Elecraft KAT2 Builder's Alert

Changes Required to Some Rev. C PCBs

Revision A July 31, 2017
Copyright © 2017, Elecraft, Inc. All Rights Reserved

Figure 1. Identifying Boards Needing this Modification.

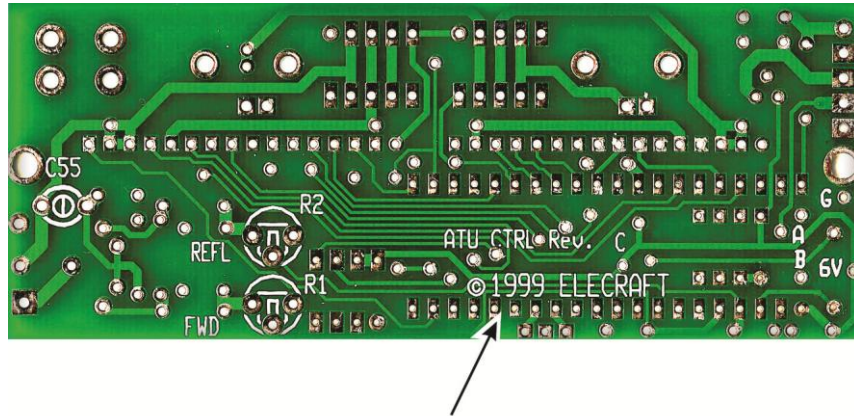
We recently discovered that some Revision C ATU Control Boards require a modification. The affected boards are the revision C boards having the revision marked exactly as shown below. If your revision C board is not marked exactly where shown below, it does NOT need modifying.

BOARDS REQUIRING MODIFICATION WILL BE MARKED HERE.
IF YOUR BOARD IS MARKED ANYWHERE ELSE IT DOES
NOT NEED MODIFYING, EVEN IF IT IS MARKED REV. C.

Figure 2. Cutting the Traces.

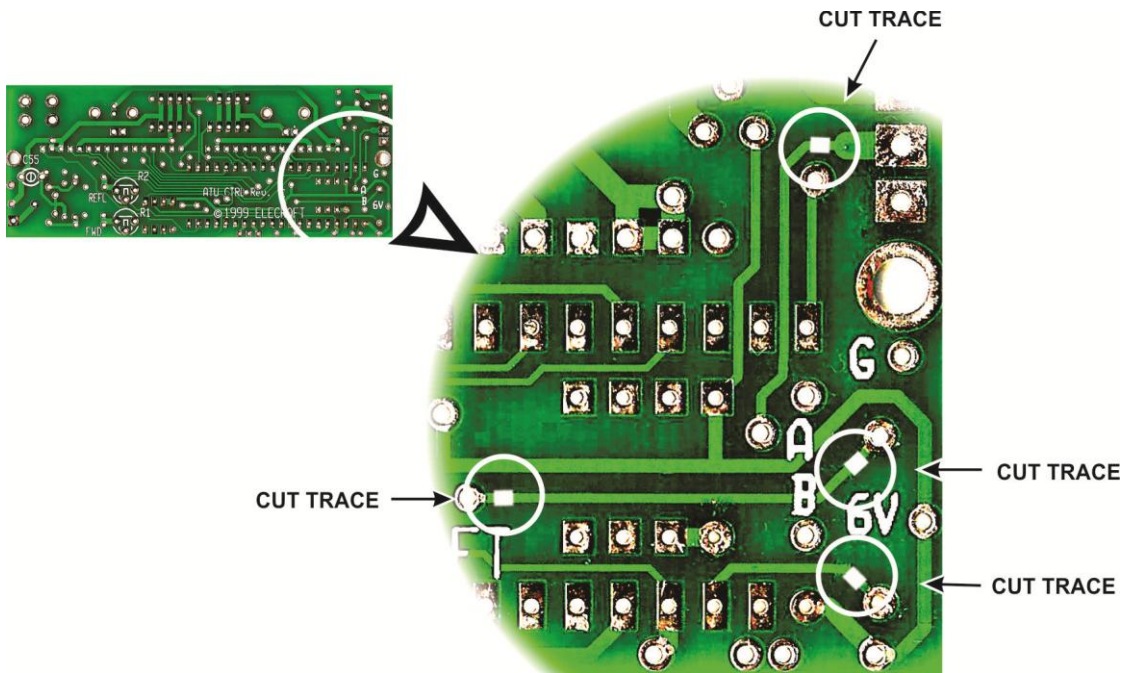
- Use a sharp knife or other tool to cut the traces at four places as shown in Figure 2 on the next page. Be sure you remove all of the metal so that the circuit is now open. Rather than a simple cut, we recommend you remove a short section of the trace is indicated.
- Install the two jumpers shown in Figure 3 on the next page. **If you have not yet mounted the parts on the pc board, install the jumpers after installing the parts with leads that go through holes to avoid prematurely filling the holes with solder.**
